From: Chris E. Howard <choward@wearehls.com>
Sent: Friday, June 5, 2020 12:05 PM
To: Wooldridge, John
Cc: James Howard; Heim, Kimber; Norton, Harvey
Subject: Re: 110412 FAI 037 Safety Project D5 Requests Cost Proposal ASAP

Subject: RE: FAI-37-6.34 Preliminary Right of Way Plans (PID No. 110412)

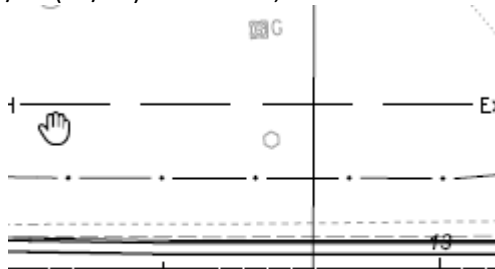
- Missing sheet 20 of 37 as Luke stated.
- Page 21/36 (22/37) Parcel 11-SH shows “Utility Pole Save” for private light poles. I would have them removed as ODOT will need to pay for them anyways (in take area) and would need to do a permit (not recommended) for the poles that are very close to the fence needing removed. Same Parcel has three of those poles (not 2) and also has a small sign near the fence that was not picked up on these plans:
